**HERITAGE PRESERVATION COMMISSION REPORT**  
Certificate of Appropriateness- Downtown Commercial Historic District.  
Section 115-320(d)(2)

**TO:** Heritage Preservation Commission  
**FROM:** Planning Staff  
**MEETING DATE:** June 23, 2022

**PROPOSAL:** The applicant is proposing alter a portion of the storefront on the property located at 305-307 Pearl Street.

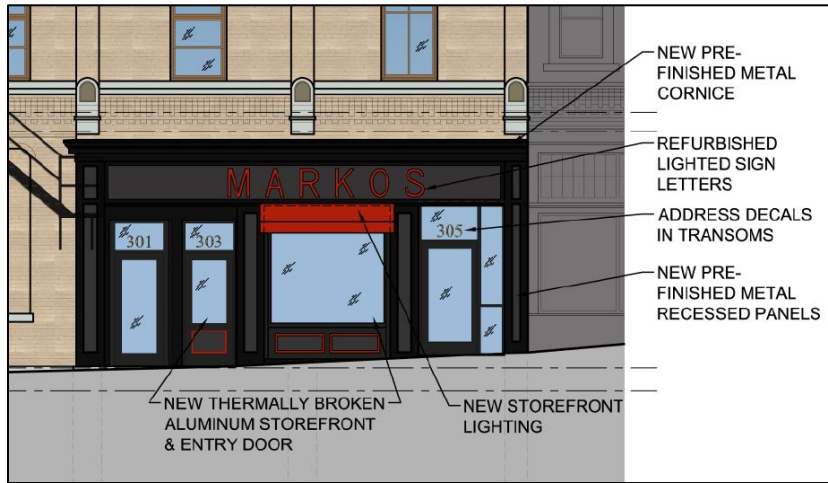
This design does not go back to a historical period as depicted in the photo to the right. The historic storefront in this location/portion of the building was completely removed in the 1950s when the steel beams were added (approximately 9' above the floor line). The old storefronts were originally about 12' high. The structure was heavily modified during that previous renovation as well. The structural brick pier was removed on the first floor and a new one was added to create the current three bay configuration. While the proposed storefront does depict a more modern version of the traditional storefront, the removal of the existing materials and look that matches the rest of the building that has been in existence for several decades is concerning. It is noted though that the storefront on the 3<sup>rd</sup> Street façade is also metal, though they did a better job of incorporating the existing brick and color scheme around it.

The proposed storefront is challenging when reviewing it under the districts design standards. They require that historic entries be preserved, and while the current storefront is not the original storefront to the building, it has been in existence for nearly 60 years and was part of the district’s National Register Nomination. On the other side, this is the type of storefront being used in some variation on the majority of storefront remodels in the district, including the 3<sup>rd</sup> Street façade if this building. Overall staff would like to a blend of the new (Black & Red) and old colors (Beige) similar of that to the 3<sup>rd</sup> Street side.

**RECOMMENDED ACTION BY STAFF:** This Certificate of Appropriateness is recommended for approval with consideration that the applicant have a color palette consistent with the storefront on the 3<sup>rd</sup> Street side and the condition that proposed sign meets the districts design standards.
